Addendum 1 for RFB927940-04

Project Name: WRC Decentralization Phase 4 & Fire Alarm Phase 3 (9279.40 & 9279.41) Bid Issuance #4
DAS RFB #: 927940-04
DAS Project #: 9279.40 & 9279.41
Date: 5/21/2026

CHANGES TO DRAWINGS

09-MD201

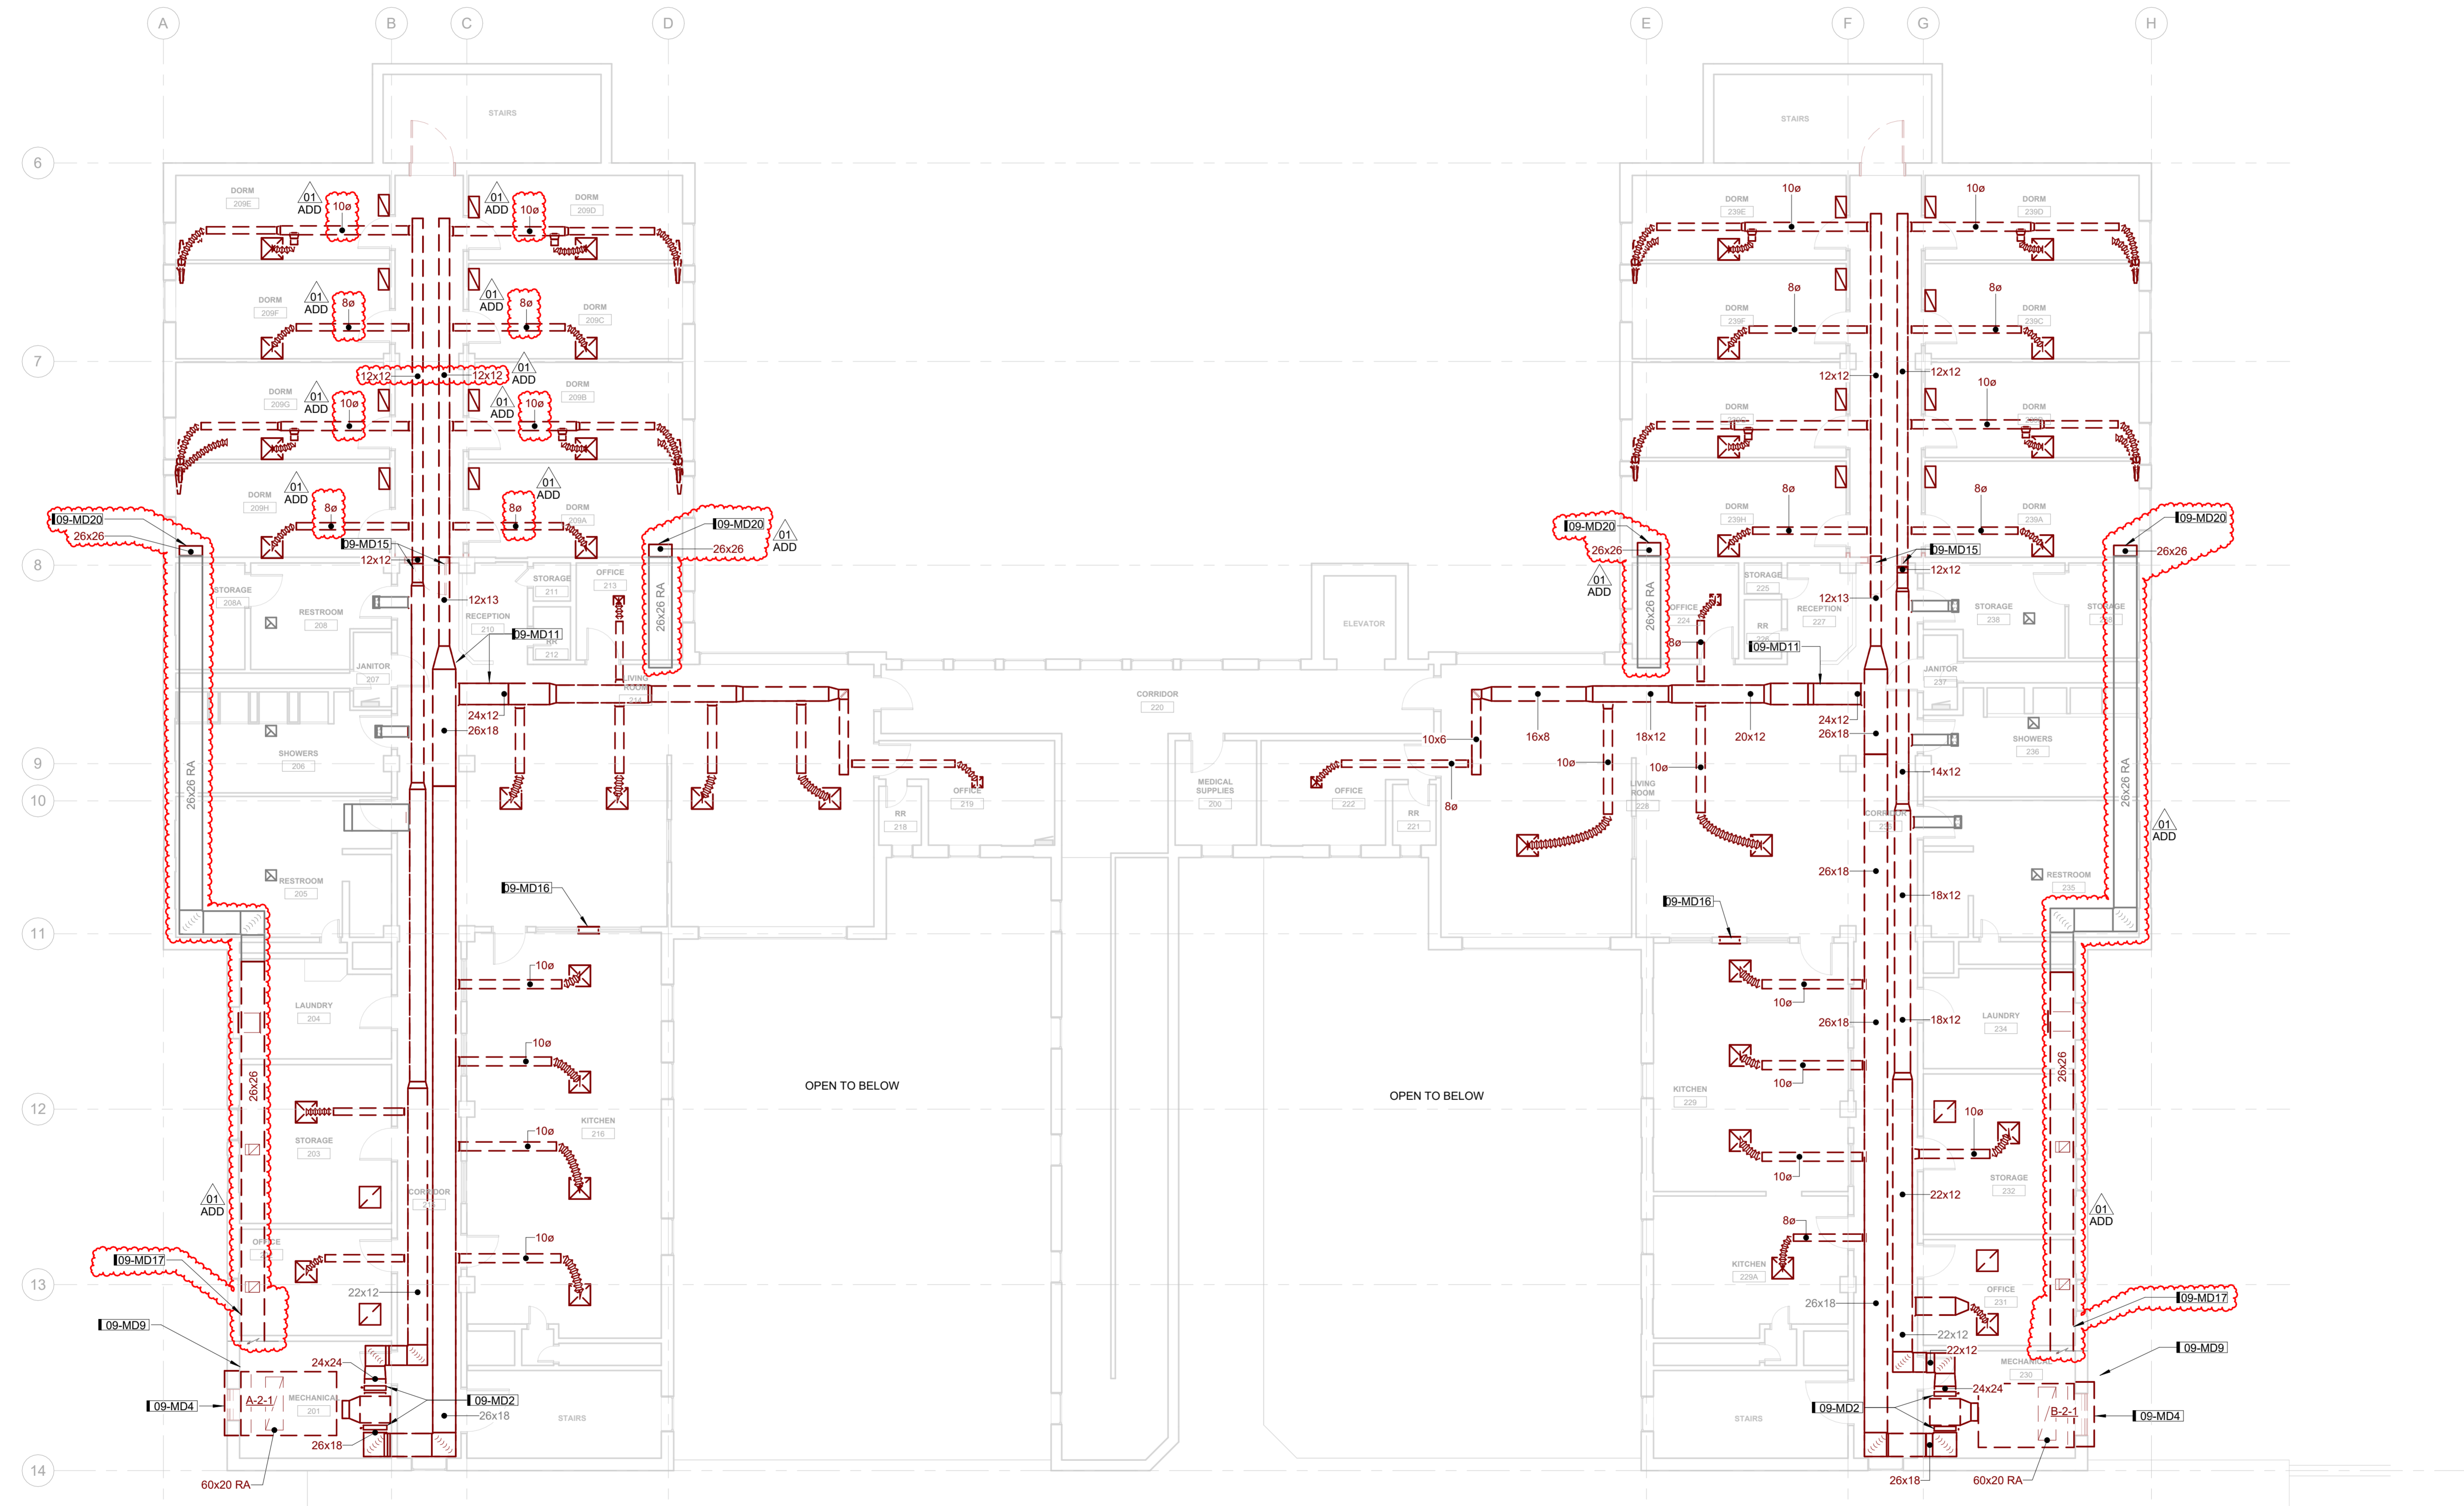
- **09-MD200 – BASEMENT MECHANICAL DUCTWORK DEMOLITION PLAN:**
 - **REVISE** extent of ductwork demolition.
- **09-MD201 – FIRST FLOOR MECHANICAL DUCTWORK DEMOLITION PLAN:**

- **ADD** existing return transfer ducts and associated demolition.
 - **REVISE** keynote 09-MD17
 - **ADD** keynote 09-MD20
- **09-MD202 – SECOND FLOOR MECHANICAL DUCTWORK DEMOLITION PLAN:**

09-MD20	DEMOLISH PORTION OF EXISTING RETURN DUCT AS INDICATED BACK TO WALL AND PREPARE DUCT FOR NEW CONNECTION. VERIFY TERMINATION POINT AND NOTIFY ENGINEER IF TERMINATION POINT DIFFERS FROM ANTICIPATED LOCATION.

09-MD202

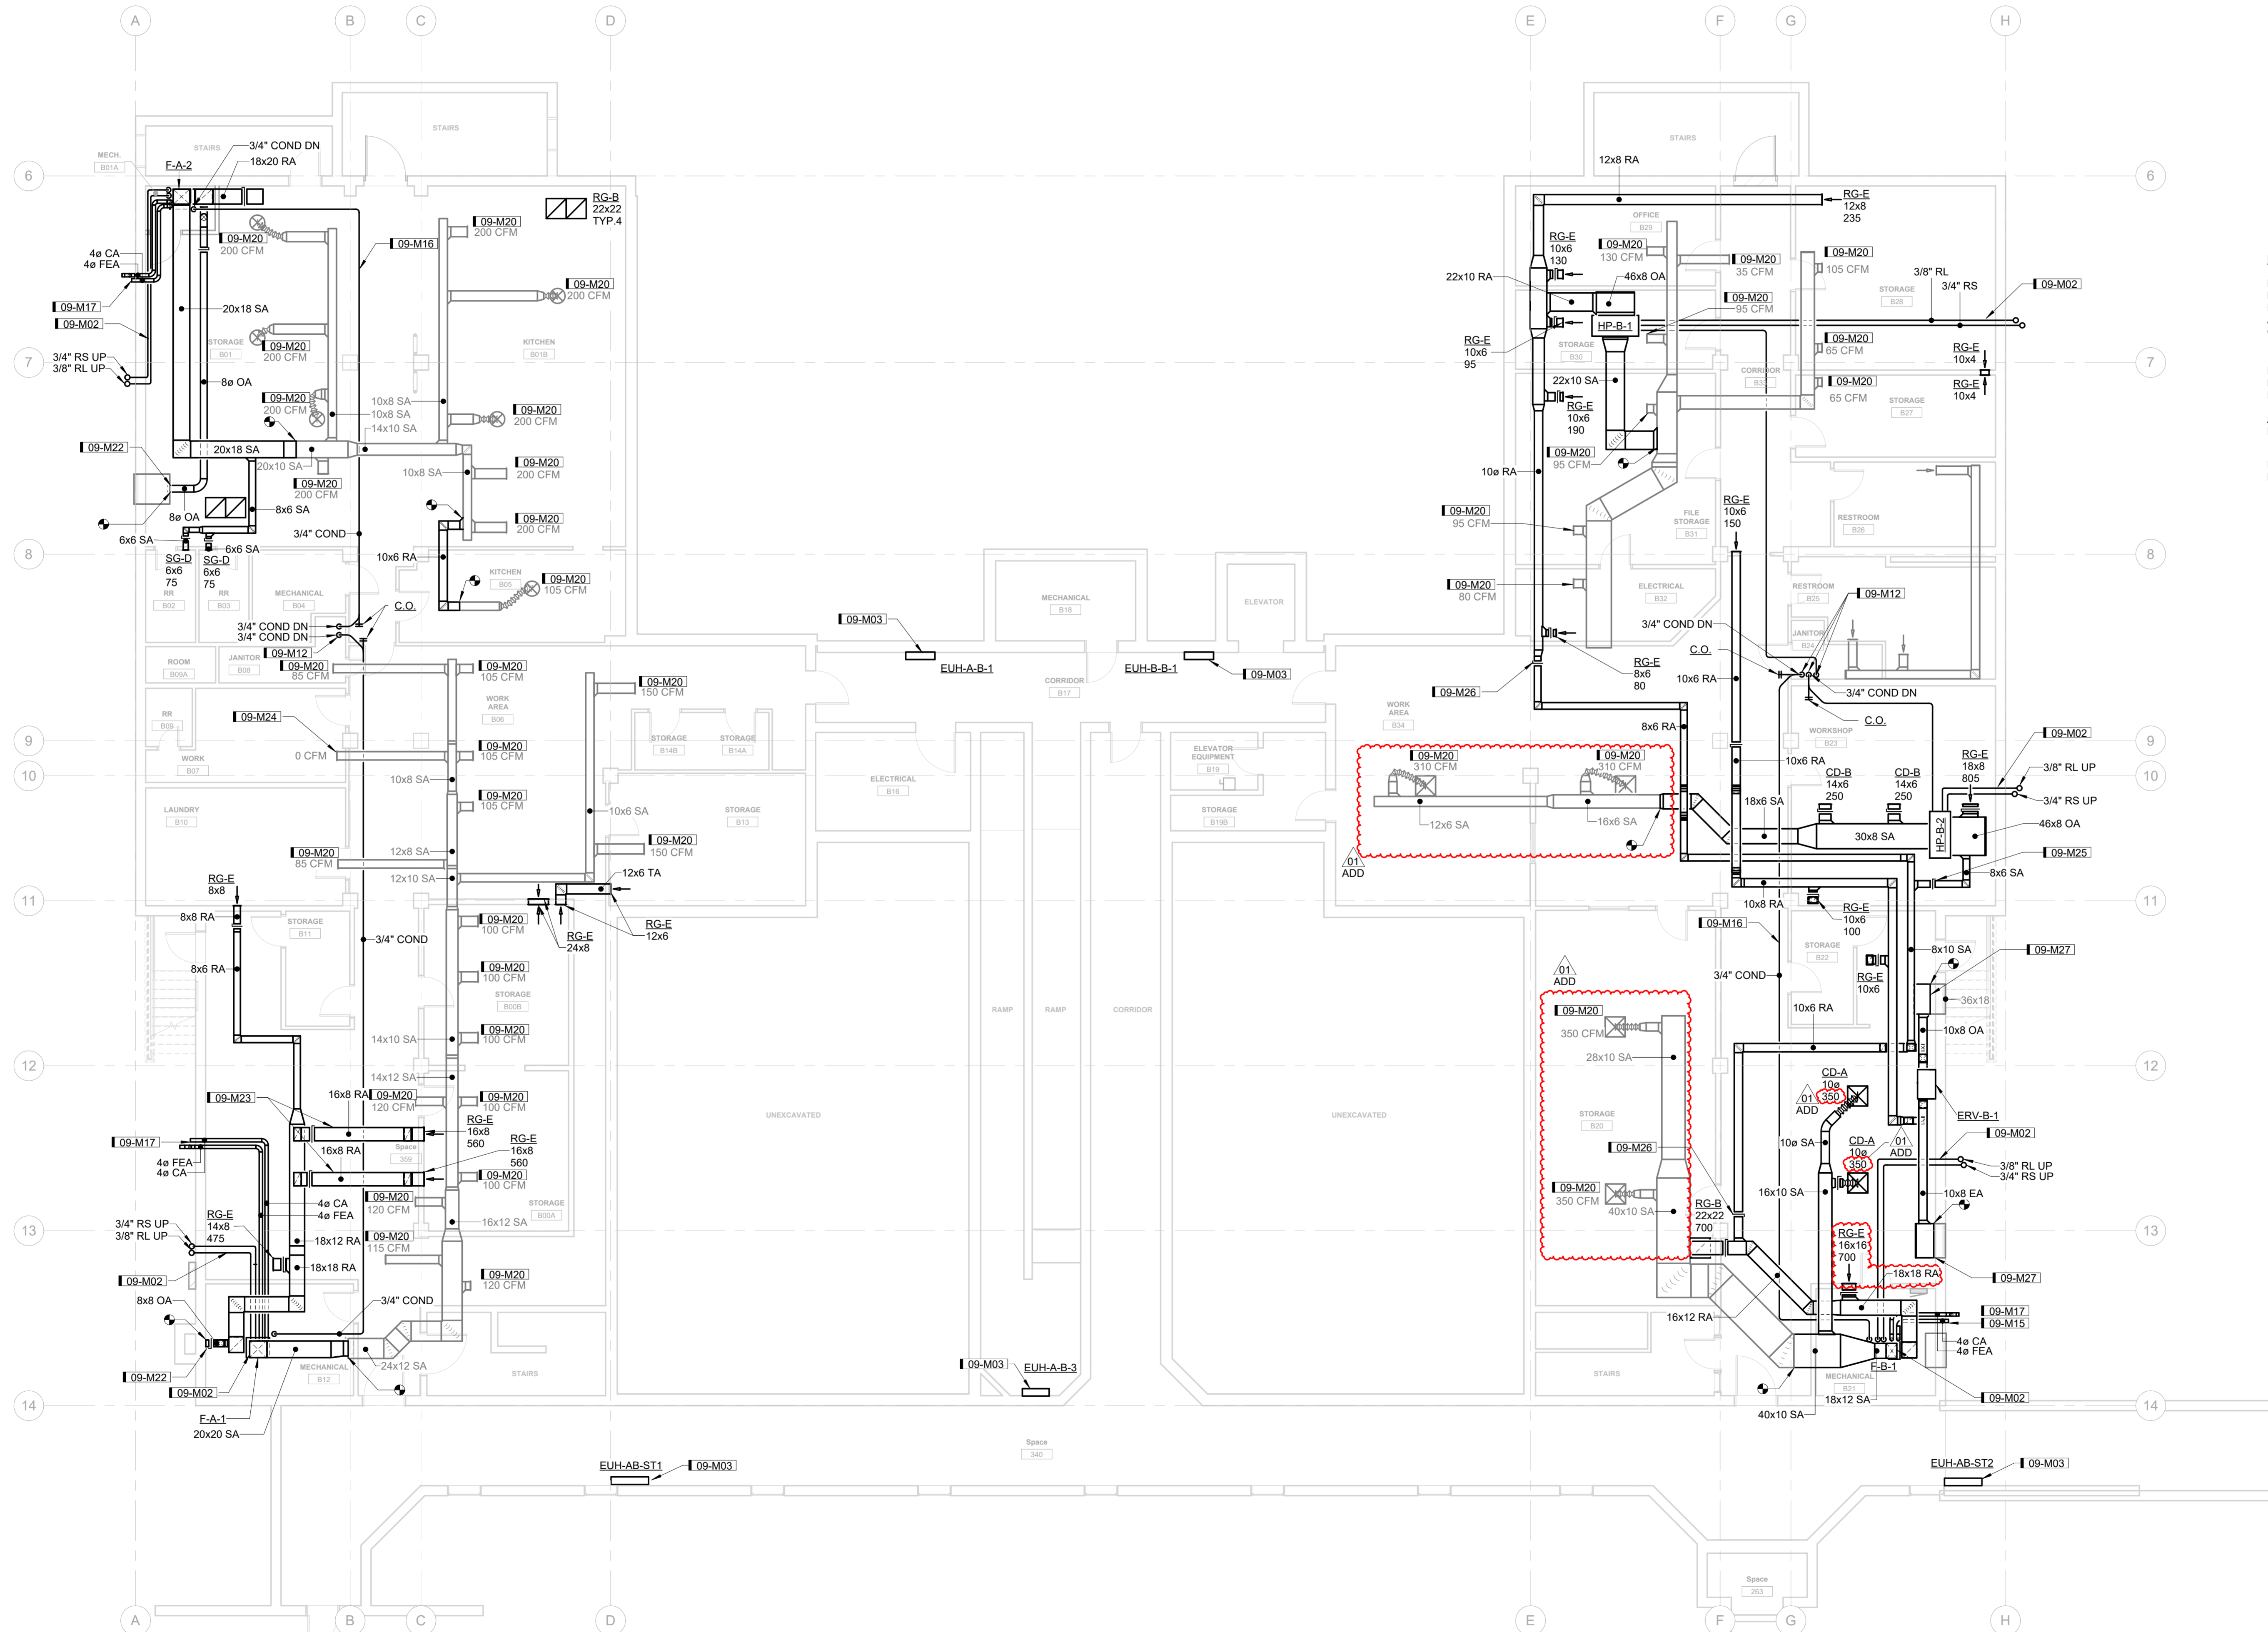
- **ADD** existing return transfer ducts and associated demolition.
 - **ADD** tags to ducts.
 - **REVISE** Keynote 09-MD17.
 - **ADD** Keynote 09-MD20.
- **09-M200– BASEMENT MECHANICAL PLAN:**

BASEMENT MECHANICAL DUCTWORK PLAN
09-M200

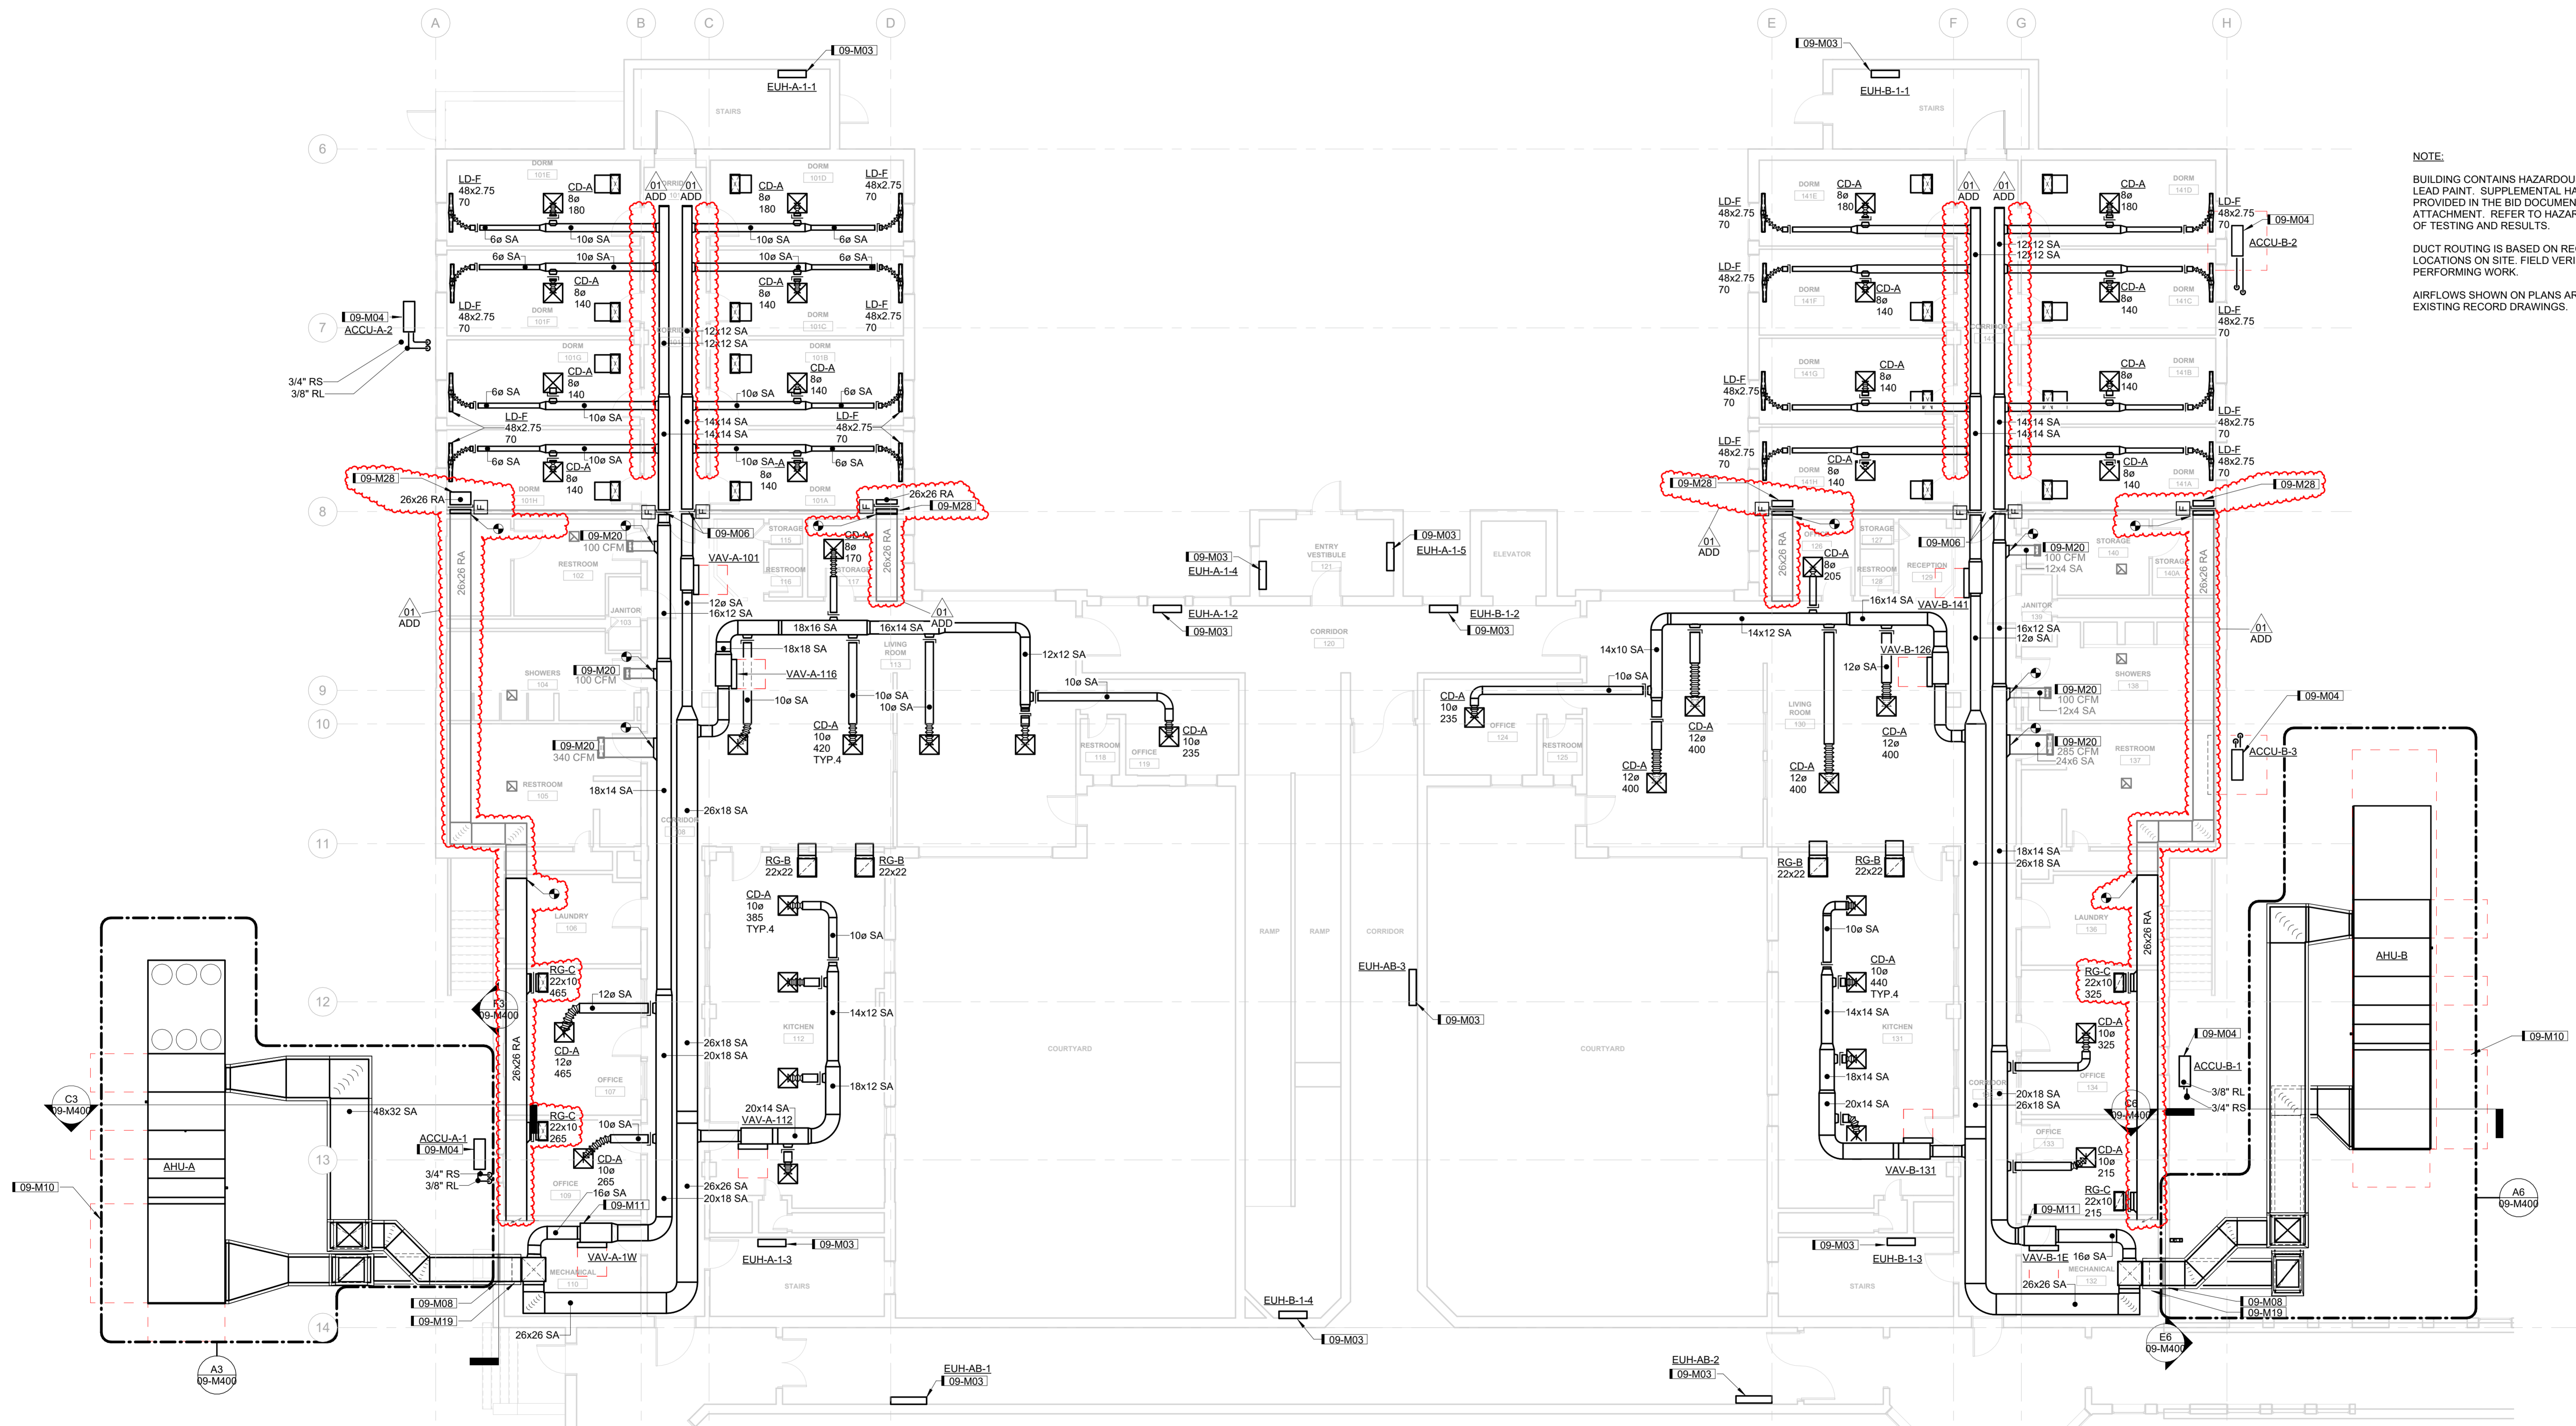
- **REVISE** supply ductwork in area B.
- **09-M201 – FIRST FLOOR MECHANICAL PLAN:**
 - **REMOVE** fire dampers between corridor and individual dorm walls.
